Access Compliance Report

Public Rights-of-Way

(Curb Ramps)

Intersection ID: 31837	Main Street: VICKSBURG_RD	Cross Street: WILLS_WY	Location: SW
ADA ID: FEC8C08E9169	Ramp Type: PerpDiag	Initial Pass/Fail: Fail	Overall Compliance: No
		Severity Score: 37.5

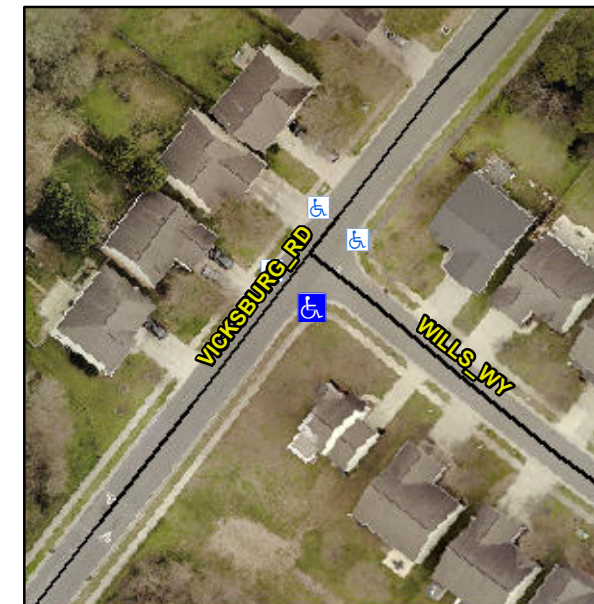
Not Found, R304.2.2, R304.5.3

Compliance	Description	Data	Compliance	Description	Data
N/A	Ramp Length (in)	48.0	No	Ramp Slope (%)	10.9
Yes	Ramp Width (in)	51.0	No	Ramp XSlope (%)	20.1
N/A	Flare Type LT	N/A	N/A	Flare Type RT	N/A
N/A	Flare Slope LT (%)	N/A	N/A	Flare Slope RT (%)	N/A
N/A	Flare Traversable LT?	N/A	N/A	Flare Traversable RT?	N/A
N/A	Landing Length (in)	N/A	N/A	DWS Provided?	N/A
N/A	Landing Width (in)	N/A	N/A	DWS Contrast?	N/A
N/A	Landing Slope (%)	N/A	N/A	DWS Length (in)	N/A
N/A	Landing X Slope (%)	N/A	N/A	DWS Full Width?	N/A
N/A	Landing Curb? (Y/N)	N/A	N/A	DWS Offset (in)	N/A
N/A	Shared Landing?	N/A			
N/A	Gutter Ponding?	N/A	N/A	Gutter Slope (%)	N/A
N/A	Gutter Lip Ht (in)	N/A	N/A	Gutter X Slope (%)	N/A
N/A	Painted X Walk1?	No	N/A	Painted X Walk2?	No
	X Walk 1 Direction	To NE		X Walk 2 Direction	To NW
N/A	X Walk 1 Width (in)	N/A	N/A	X Walk 2 Width (in)	N/A
	X Walk 1 Slope (%)	8.5		X Walk 2 Slope (%)	4.3
	X Walk 1 X Slope (%)	3.6		X Walk 2 X Slope (%)	10.6

Remove & Replace Curb Ramp With Two New Directional Ramps or Equivalent.
